CITY OF NOVI CITY COUNCIL
AUGUST 8, 2022

SUBJECT: Approval of (1) the request of Sakura Novi Land Development LLC for JSP 22-09 Sakura Novi for Preliminary Site Plan with Site Condominium, Phasing Plan, Wetland Permit, Woodland Permit, and Storm Water Management Plan, and (2) First Addendum to the PRO Agreement. The subject property is zoned TC-1 with a Planned Rezoning Overlay (PRO), which conditions development to the terms of a PRO Plan and Agreement. The site is approximately 15 acres in size and is located north of Grand River Avenue, south of Eleven Mile Road, and east of Town Center Drive (Section 23). The applicant is proposing to develop a mixed-use development including commercial retail, office, and restaurant uses, and multifamily residential units.

SAKURA NOVI: JSP22-09

NOT FOR CONSTRUCTION **C-2.1**

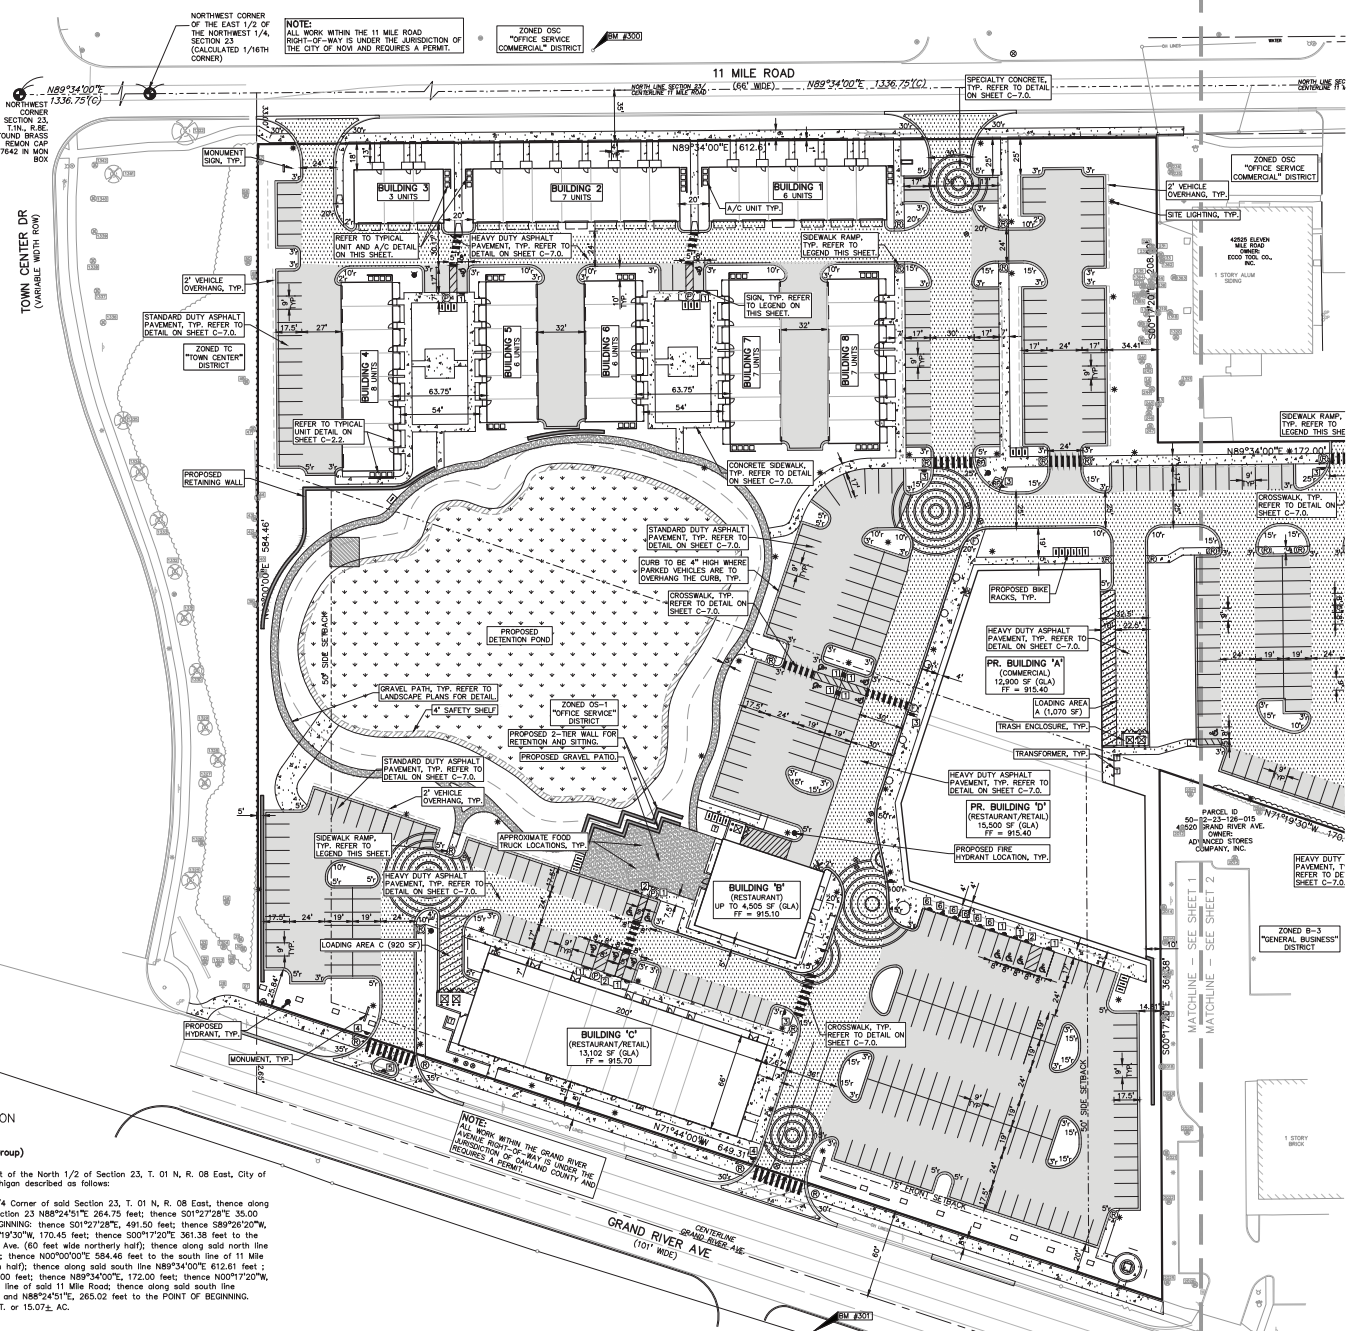
- b. Remove the "Phasing Note" (Sheet C-2.0) as such commercial phasing is no longer proposed.
- c. On the western side of the site, 17.5-foot parking stalls require a 1.5-foot vehicle overhang beyond the curb. Ensure the placement of the retaining wall will not interfere (Sheet C-2.1).

- d. All parking spaces designated "Van-Accessible" require an 8-foot access aisle (Sheet C-2.1, SW of Building B).
- e. A 5-foot access aisle is required between 2 ADA spaces south of Building D (Sheet C-2.1).

- f. The 17-foot parking spaces south of Building D require a 2-foot vehicle overhang. Ensure the placement of the signs will not interfere (Sheet C-2.1).

NOT FOR CONSTRUCTION **C-2.6**

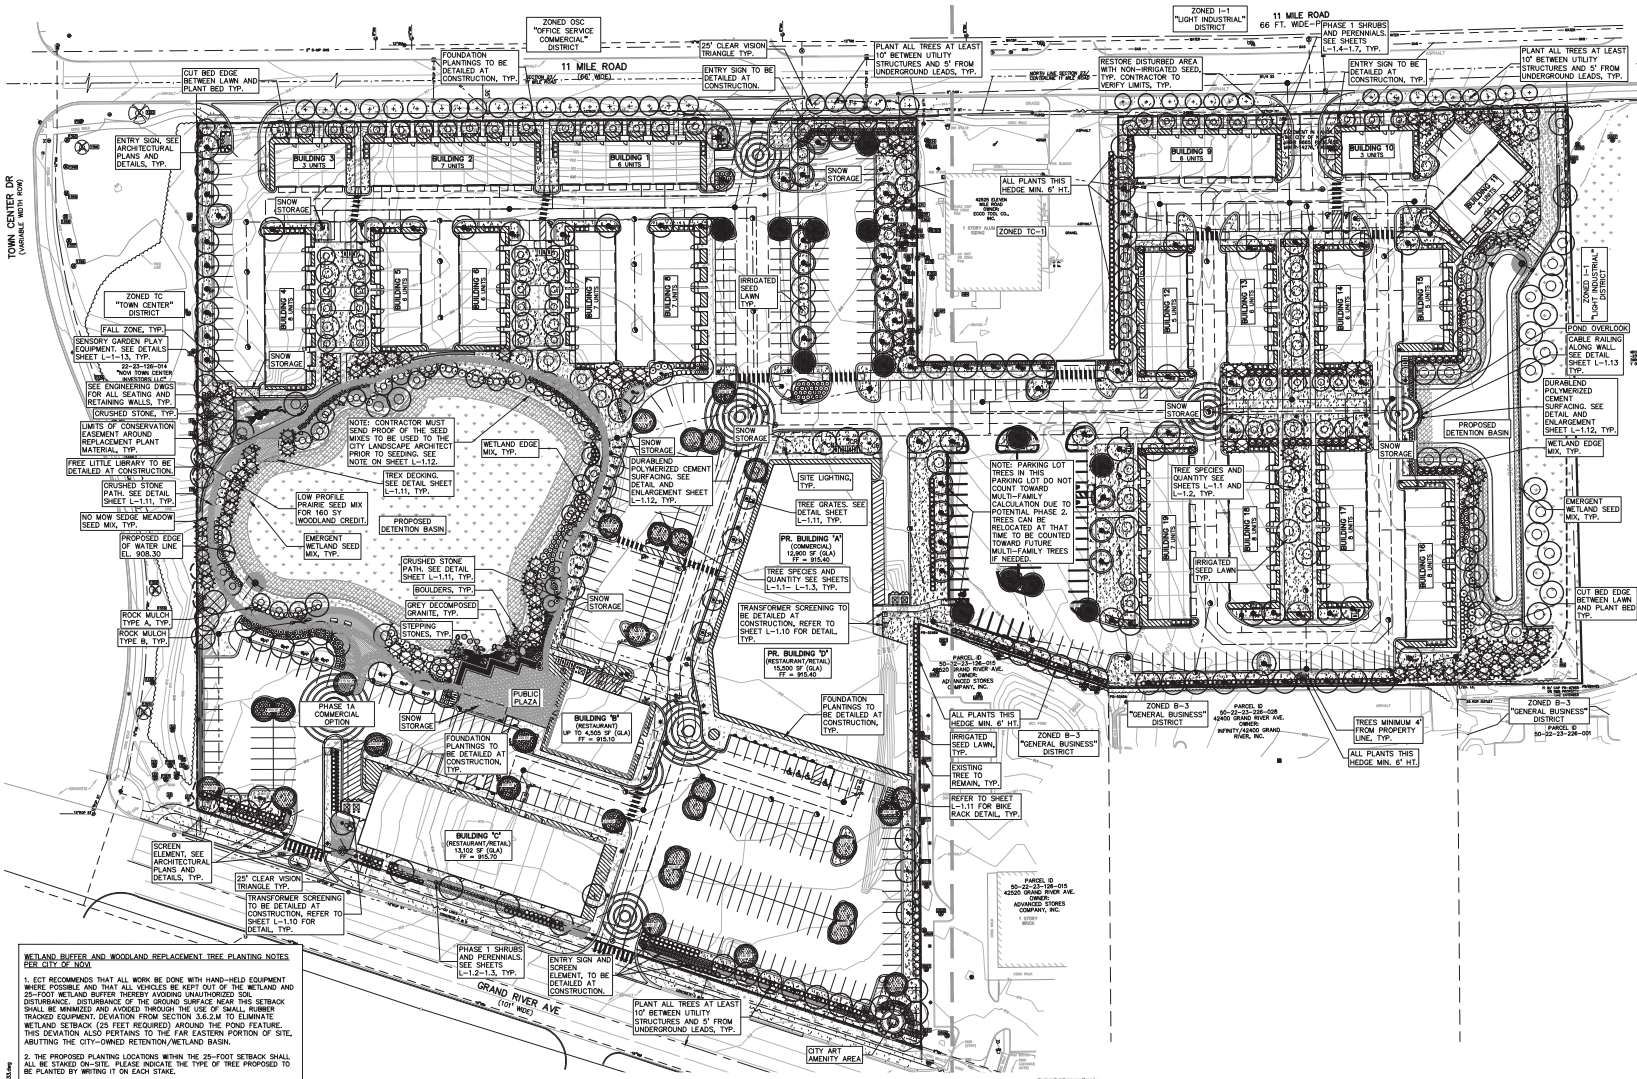
2. Condominium Plan (Sec. 6.3): The applicant has previously indicated ownership of the property will be organized within a Condominium. **A plan for the condominium unit boundaries has been included on Sheet C-2.6 and will need to be reviewed and approved by the Planning Commission and City Council along with the Preliminary Site Plan. Currently the plan shows 5 separate units (3 commercial and 2 residential), and some areas of general common element. The Unit Plan shows all the commercial areas as Unit 1, and both residential units as Unit 2. Each unit will need to be uniquely numbered, as the Units are not contiguous, so each will receive its own parcel number. A draft Master Deed and Exhibit B will need to be submitted for review and approval with the Final Site Plan submittal.**

Condominium unit boundaries are being coordinated with Novi's attorney and will be shown/detailed as mutually agreed at the time of Final Site Plan submission. See **Attachment Sheet 1** for current status of discussion.

NOT FOR CONSTRUCTION **L-1.0**

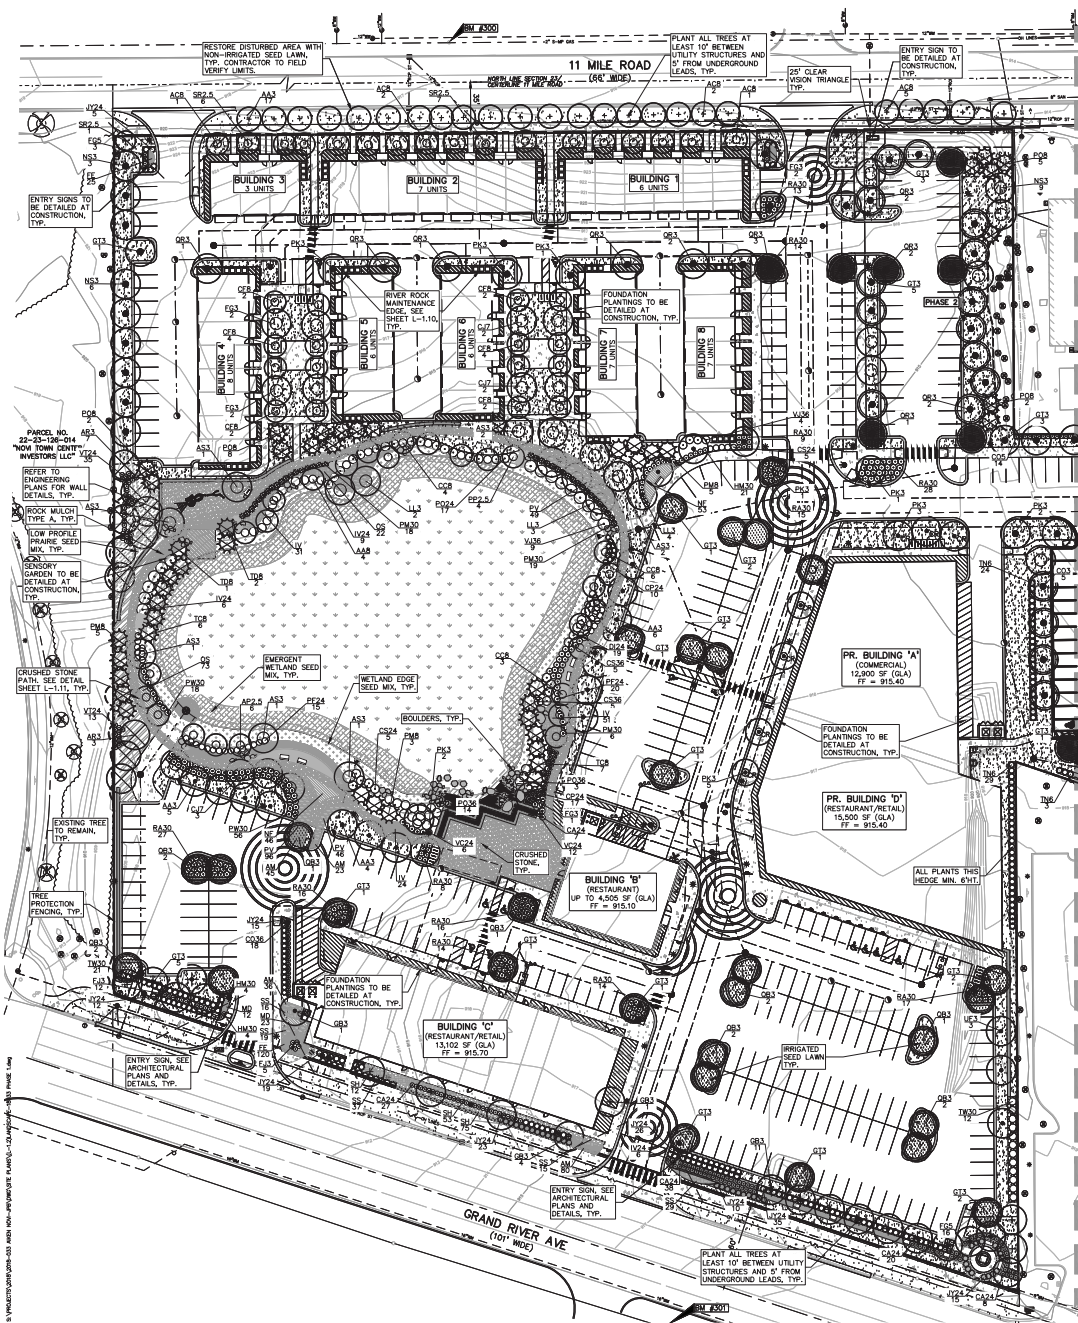
- i. The Woodland Conservation Easement boundary on the landscape sheet is very difficult to read. Please ensure the easement is shown on another sheet in the plan set that is less busy (Sheet L-1.0).

- (5) Recreational Amenity/Pond Area. **The site plan does not specifically show the play area on the plan. A pond platform is shown on the overall site plan. Landscaping sheet L-1.0 indicates “Sensory Garden Play Equipment” near the pond platform, and details are provided on Sheet L-1.13.**

The note regarding a landscape easement for the evergreens on the adjacent property was added to L-1.0 and L-1.1.

An additional leader was added to the callout on L-1.0 regarding trees being 5' from storm leads.

Additional minimum hedge height callouts were added to L-1.0.

Cost opinion has been added to sheet L-1.0.

Figure 2.
Tree Protection Detail, Page T-1.0
Tree Protection Fencing is incorrectly shown at the dripline, but text on the right indicates it will be placed correctly (1-foot outside dripline)

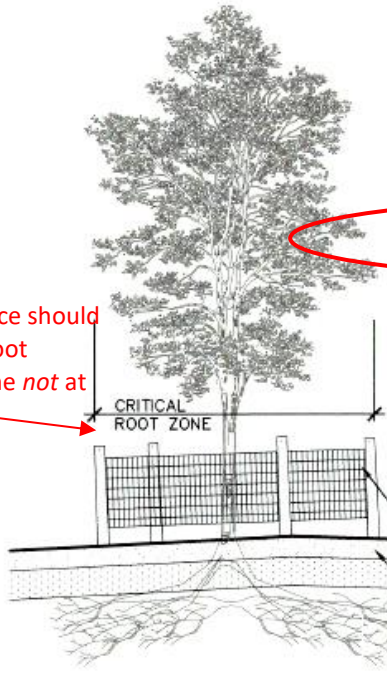
i. The Tree Protection Detail on page T-1.0 of the original site plan must be revised to show proper placement on the woodland protection fencing outside the CRZ of the tree (1-foot beyond the dripline).

1. **This comment has been addressed by the applicant on the revised site plan. Note, the Tree Protection Detail on page T-1.0 of the revised plan shows the tree protection fence at the dripline of the tree, when it should be placed at the critical root zone (1-foot outside the dripline); however, the text next to the detail indicates the tree protection fencing will be correctly placed 1-foot outside the dripline. See Figure 2.**

The tree protection detail has also been updated, see sheets L-1.10 and T-1.0.

The tree fencing detail verbiage has been updated per the review. Please see sheets L-1.10 and T-1.0.

Figure 3. Page L-1.0

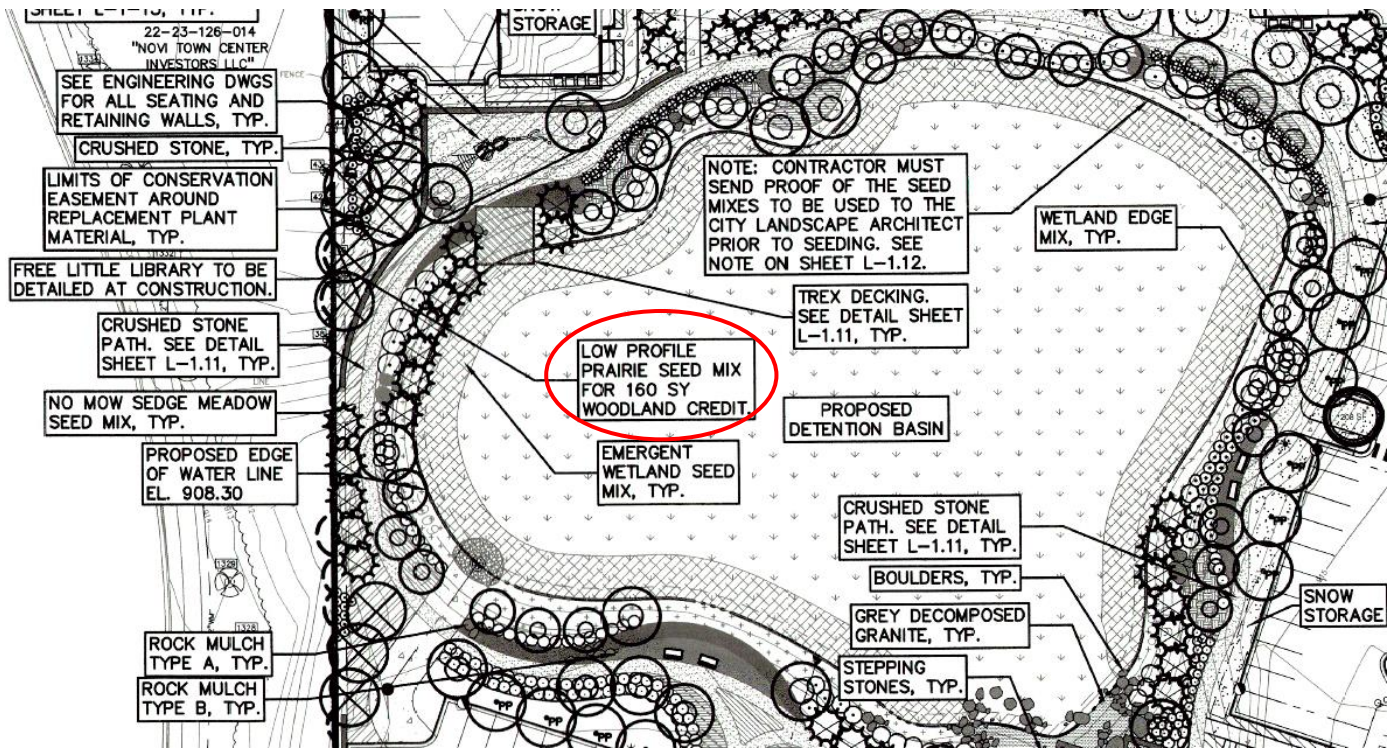
- i. Nine (10) 'Red Sunset' red maples – native
 - ii. Forty-eight (48) Compact American cranberry bush – native
 - iii. One hundred-sixty (160) square yards of native seed mixes - The applicant has provided the native seed mixes on Page L-1.12 of the site plan. The applicant has identified the area west of the wetland will be seeded to fulfil this credit. See Figure 3.

Figure 4. Page C-3.1
Proposed grading within tree protection fencing that surrounds trees proposed to be protected

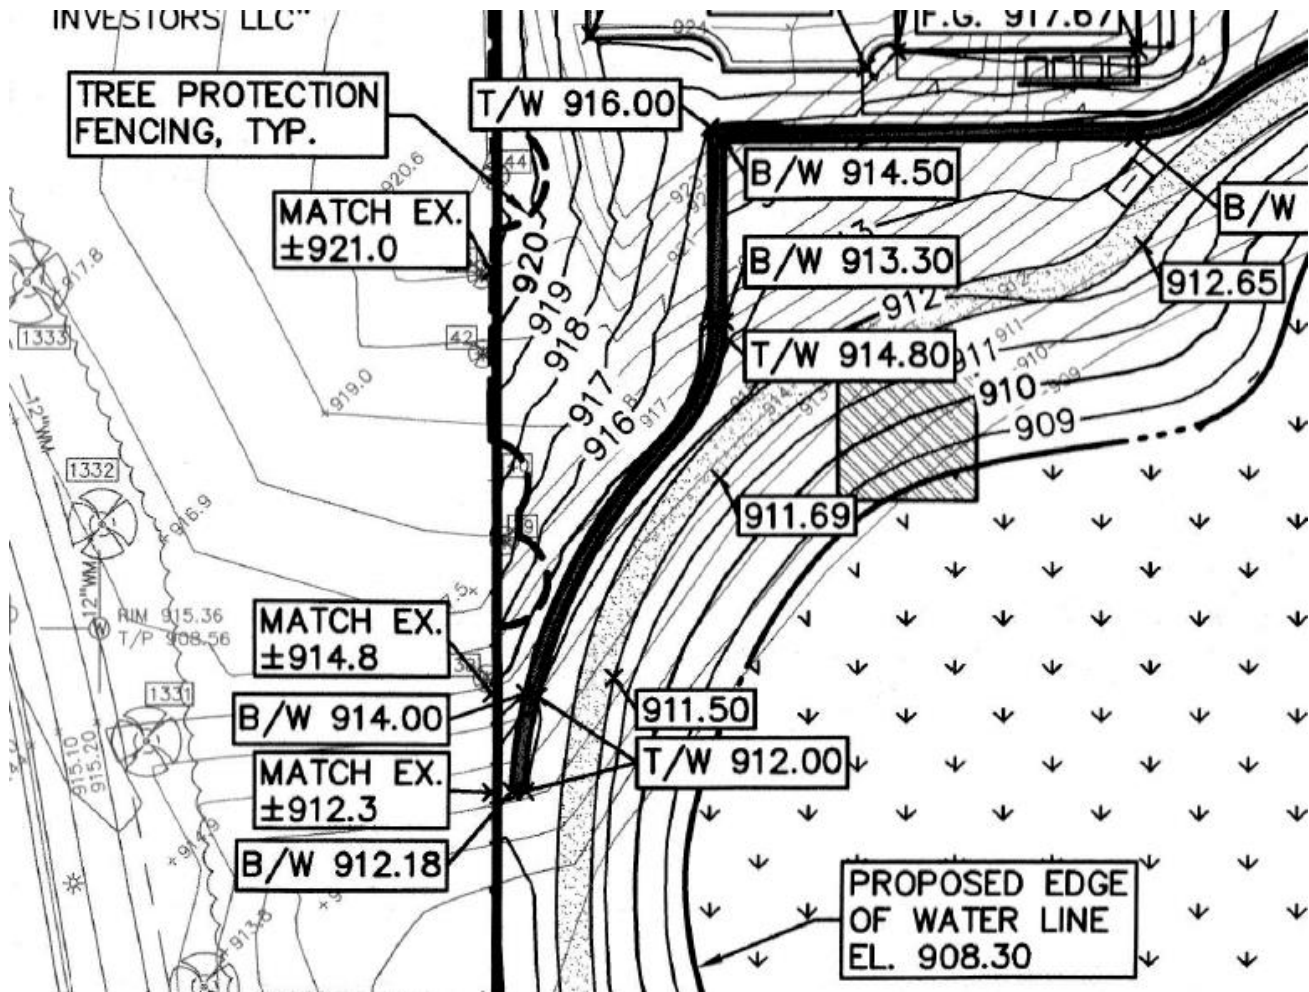
- i. **Grading plans on sheets C-3.1 and C-3.2 do not show the accurate location of the critical root zone of preserved regulated woodland trees and the tree protection fence appears to be within the critical root zone of preserved woodland trees.**
Revise plans to:
 - 1. Accurately depict the location of the critical root zone per Section 37-9(1)
 - 2. If tree protection fence must be located within the critical root zone of preserved regulated woodland trees, provide the woodland replacement credits required per the woodland replacement requirements outlined in

3. The grading comments were partially addressed by the applicant in the revised plan. Figure 4 shows where grading is proposed to take place within tree protection fencing on the revised plan.
6. The applicant does not use consistent symbology for trees on the original site plan. The plan should be revised to show a tree and the critical root zone for each tree.
 - a. This comment has been addressed by the applicant in the revised site plan.

A note has also been added to T-1.0 and the grading plan stating “Tree protection fencing shall be placed per the provided detail on this sheet, regardless of the graphic representation on the plan. Grading shall remain outside of the fence line, typ.”
